Saratoga Retail: DR08-0003-R
Exhibit A
Location Map

SARATOGA RETAIL
 PHASE 2
 ONSITE IMPROVEMENT PLANS
 SITE PLAN
 EL DORADO HILLS, CA

EL DORADO COUNTY DEVELOPMENT SERVICES PLANNING COMMISSION STAFF REPORT

Exhibit J

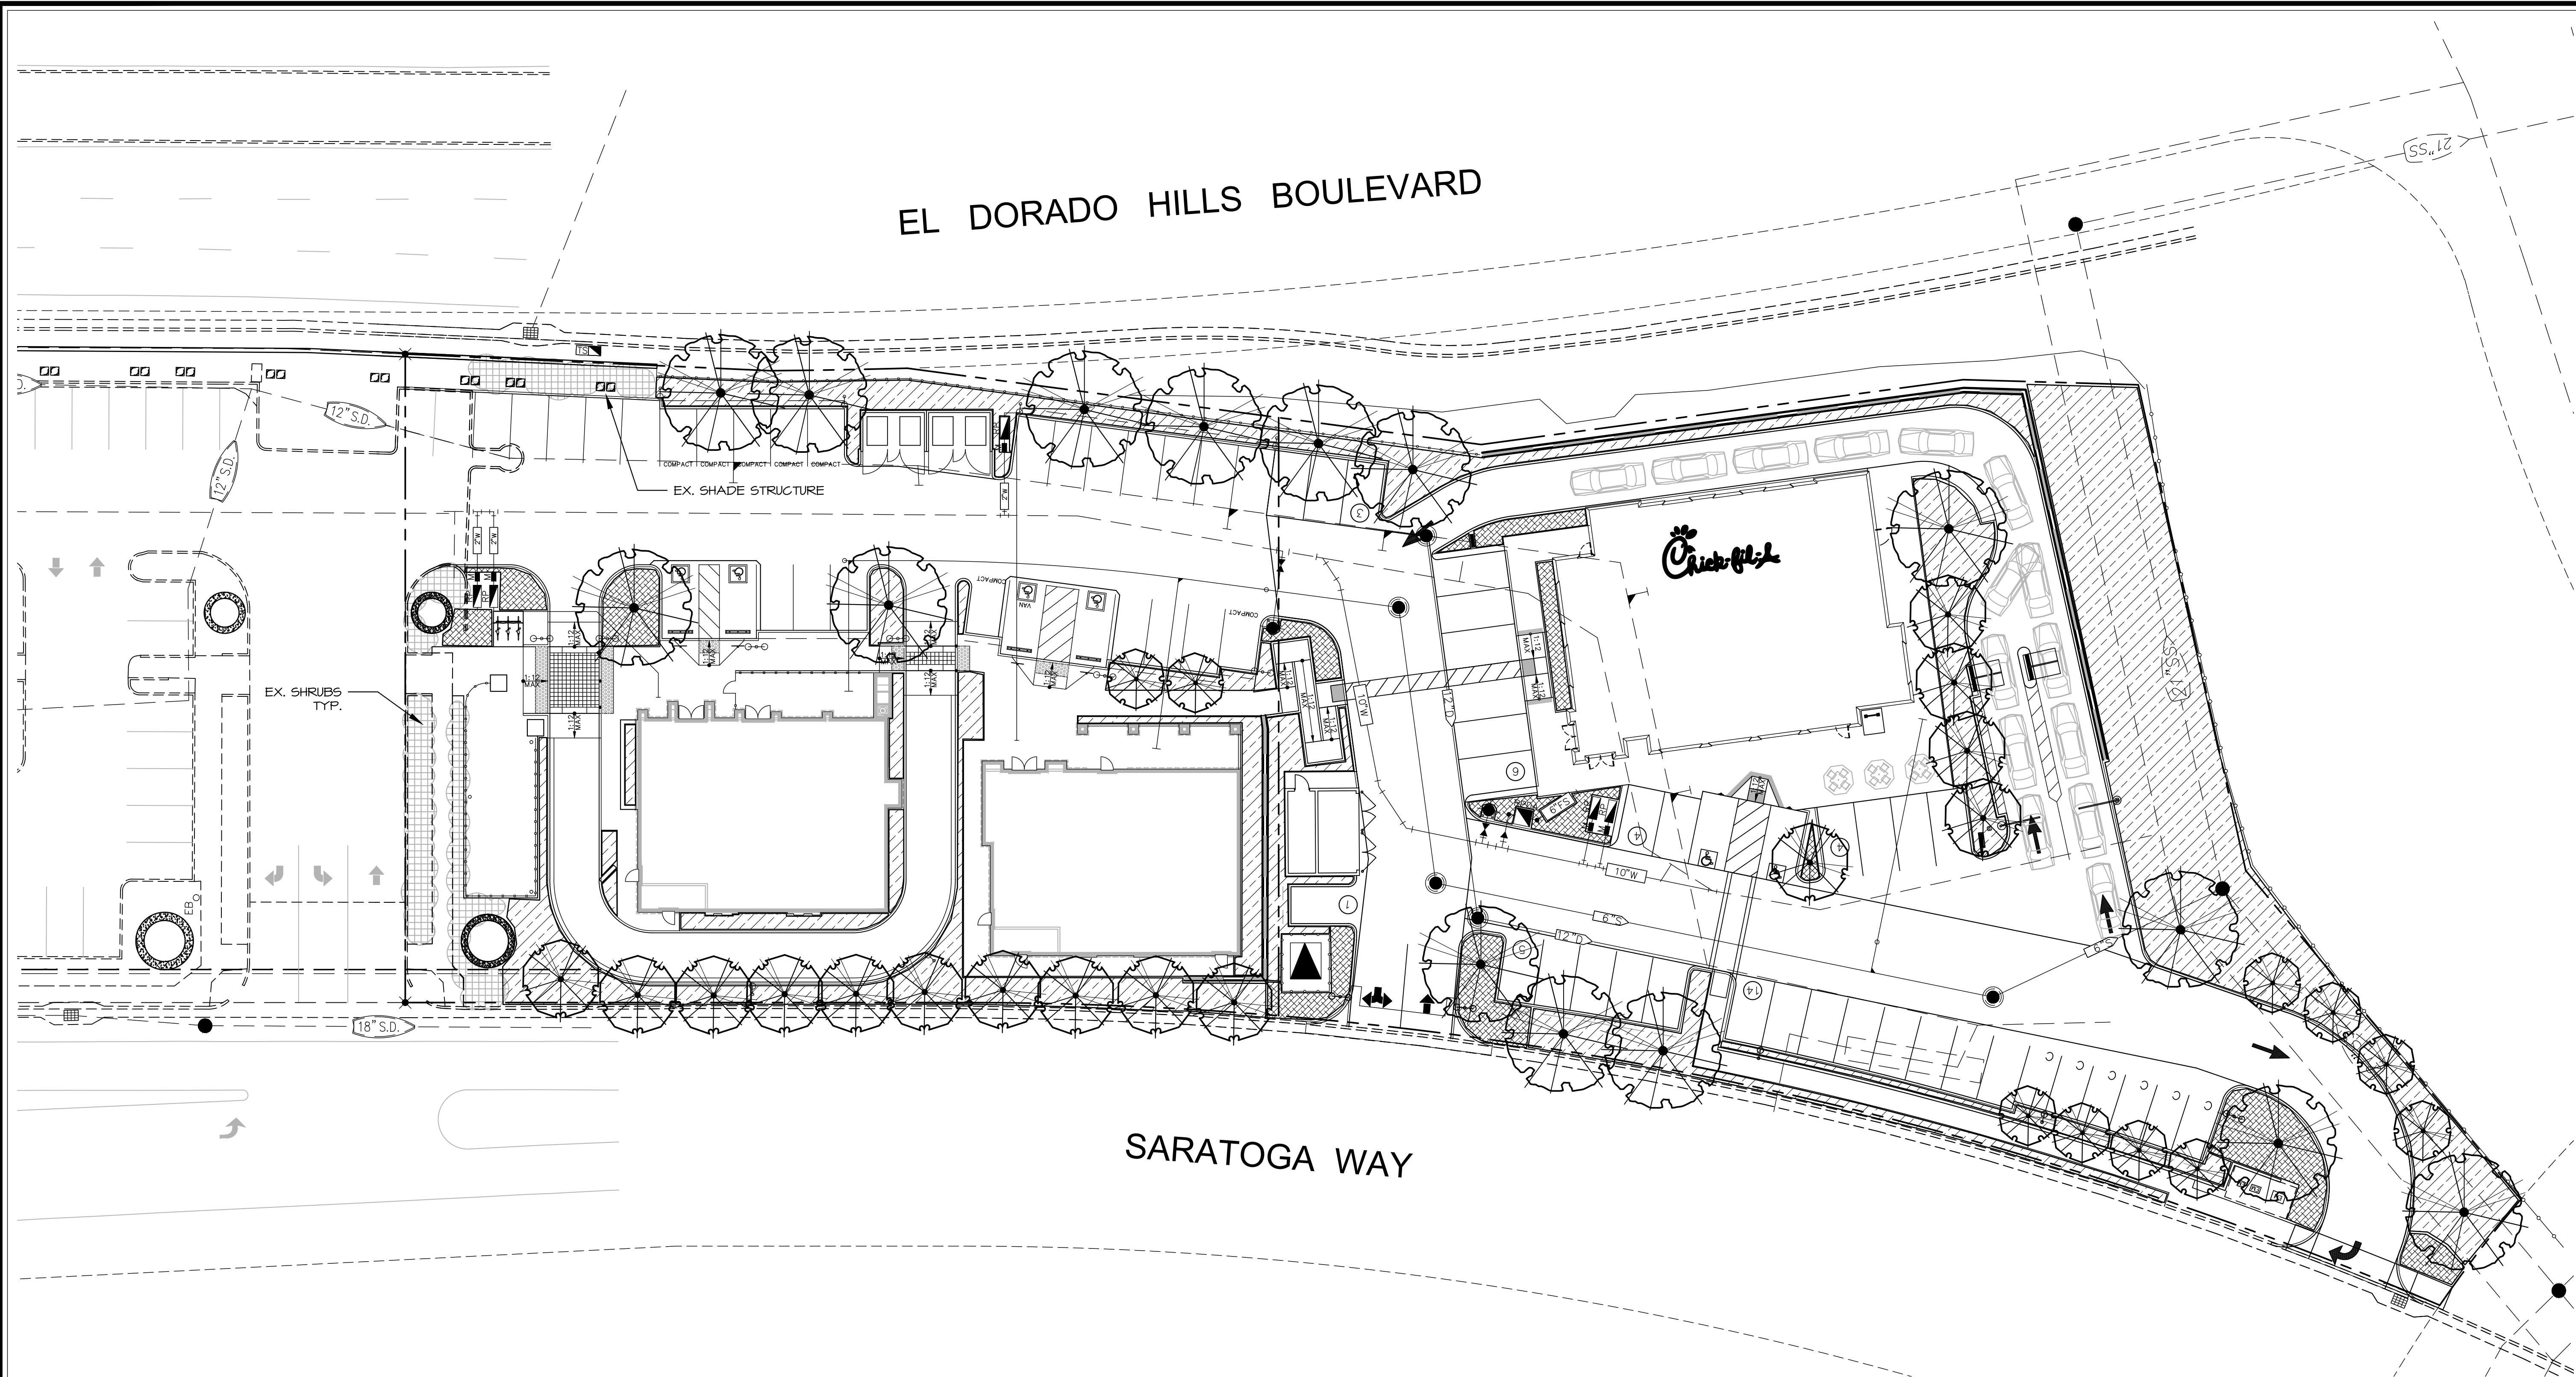
3. **MM-VIS-1:** The applicant shall include one landscape island/finger within the parking area associated with Walgreens along Saratoga Way. This planter shall be planted with at least one large shade tree. In order to break up other long uninterrupted rows of parking spaces, the applicant shall plant large shade tree clusters (2-3 trees) every ten parking spaces within the perimeter landscape buffer to break up views of the parking lot as seen from the surrounding residential properties and Saratoga Way.

Timing/Implementation: The applicant shall revise all site plans and grading plans to include a landscape island within the parking area associated with Walgreens along Saratoga Way. The landscape plan shall also include large shade tree clusters (2-3 trees) every ten parking spaces within the perimeter landscape buffer.

16. The final landscape plan shall meet Zoning Ordinance Chapter 17.18.090. The applicant shall revise the proposed landscape plan consistent with recommendations in Condition #3. The applicant shall submit the revised landscape plan for review and approval by El Dorado County Planning Services and the El Dorado Community Services District prior to issuance of grading and building permits. The property owner shall maintain landscaping for the life of the project.
17. All outdoor lighting shall conform to Sections 17.14.170 and be fully shielded pursuant to the Illumination Engineering Society of North America's (IESNA) full cut-off designation. In addition, the following apply:
 - a. External lights used to illuminate a sign or side of a building or wall shall be shielded in order to prevent light from shining off the surface to be illuminated.

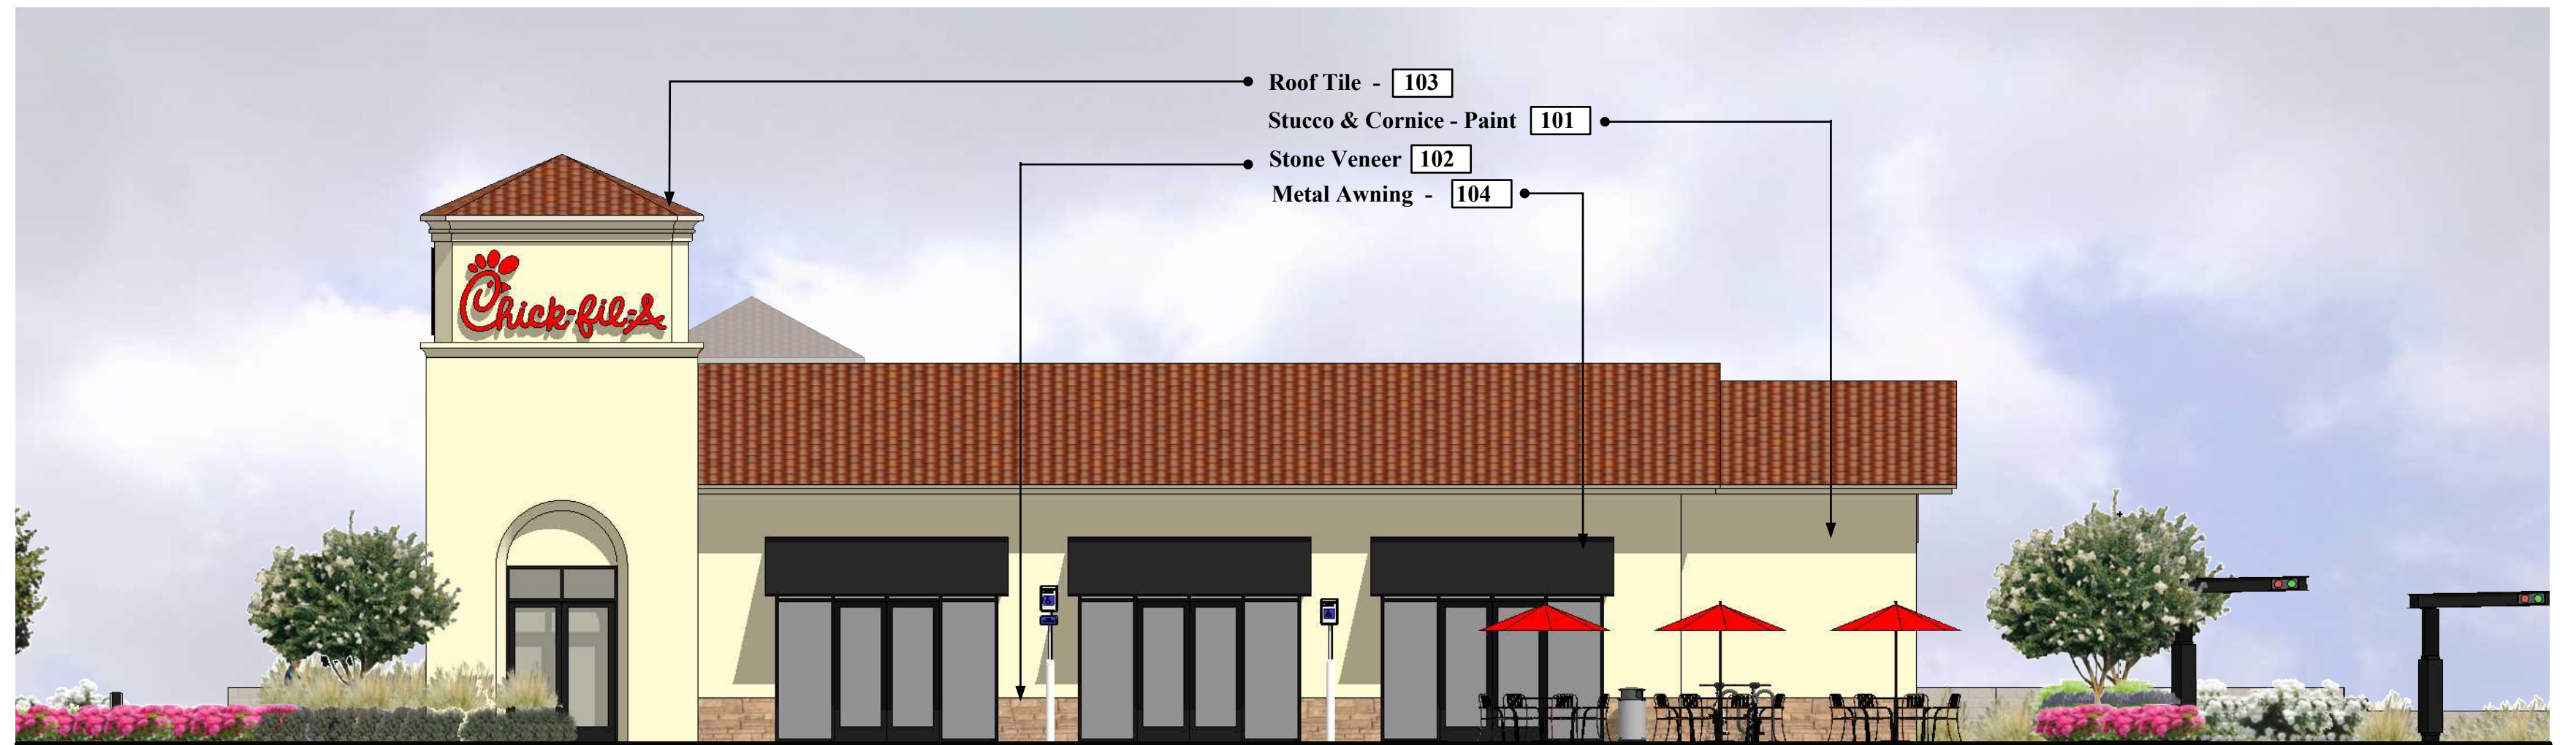
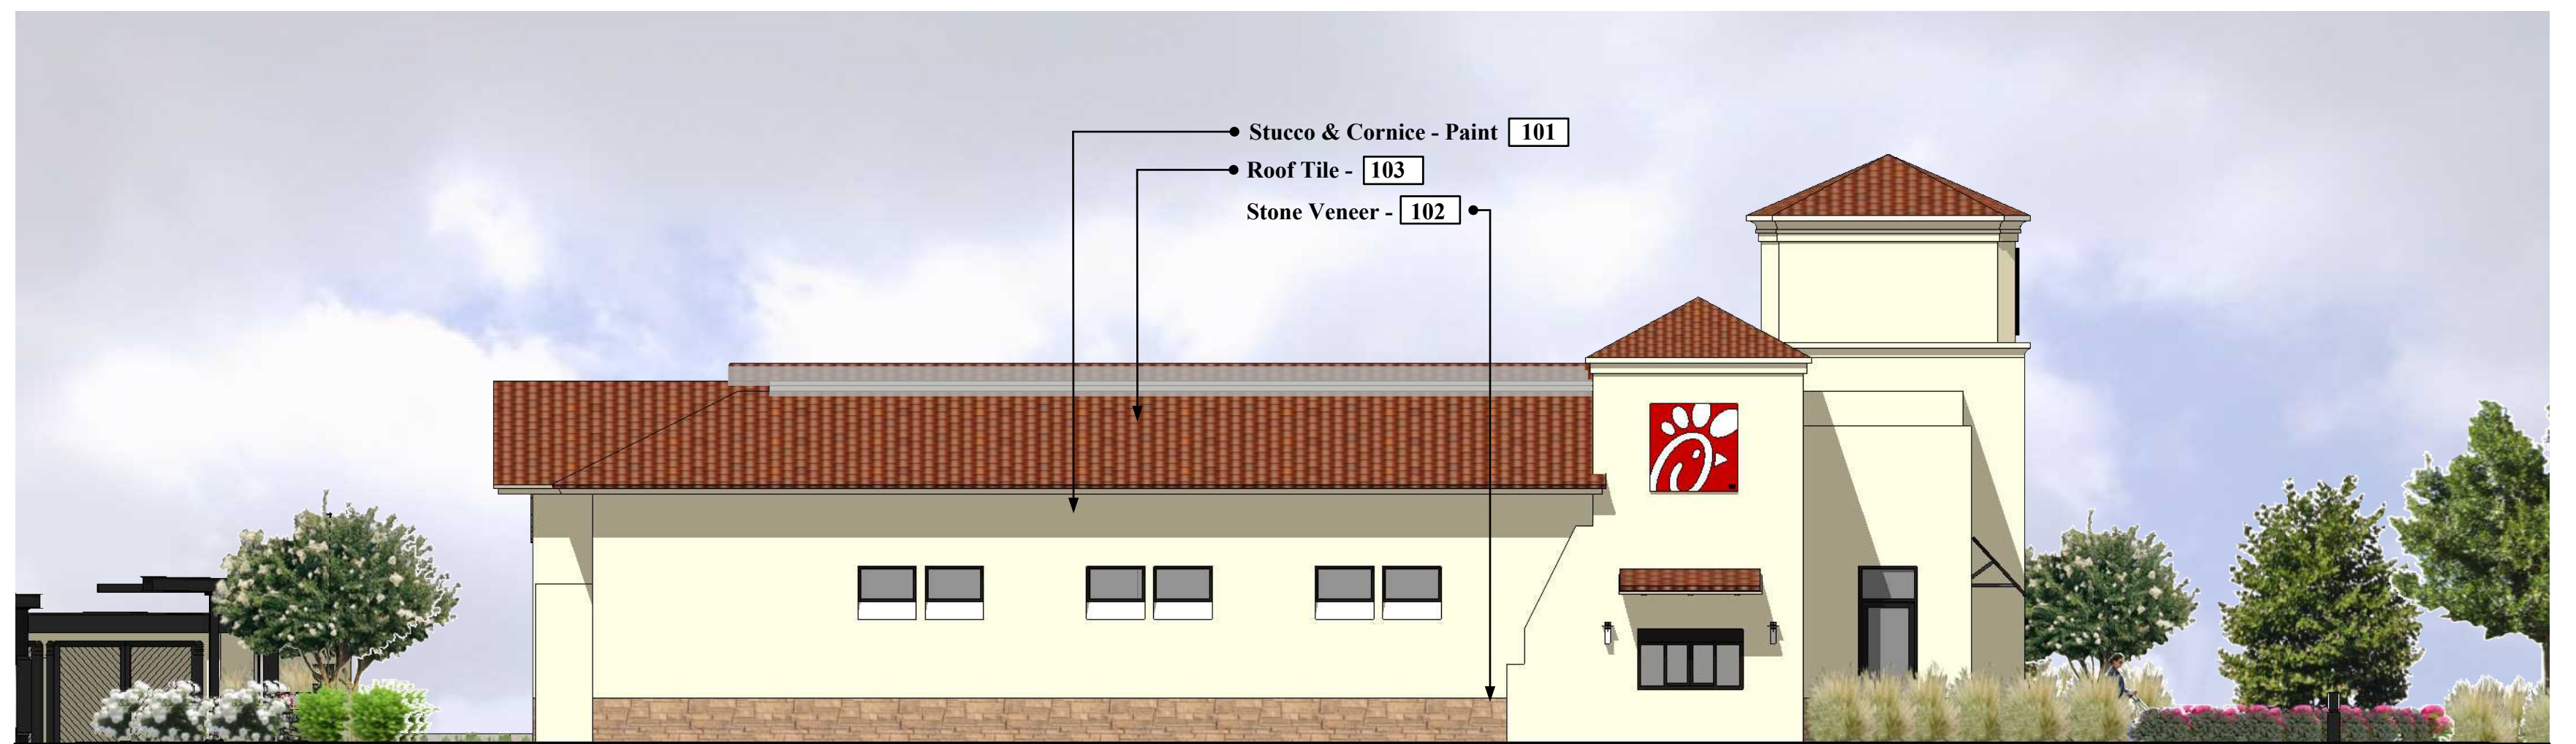
The applicant has worked with area advisory groups and residents of the neighborhood to address design concerns. Specifically, the applicant has redesigned the tower element and entrance to Walgreens to provide more articulation in the entrance way. The trash enclosure has been rotated around to the side of the site so that it is not directly in the line-of-sight of residences to the west. The trash enclosure and drive-thru pharmacy area will be screened from El Dorado Hills Boulevard with landscaping, decorative metal railings, and decorative walls (stucco, stone veneer, stone caps) that will serve to provide an attractive view as seen from El Dorado Hills Boulevard/Saratoga Way intersection.
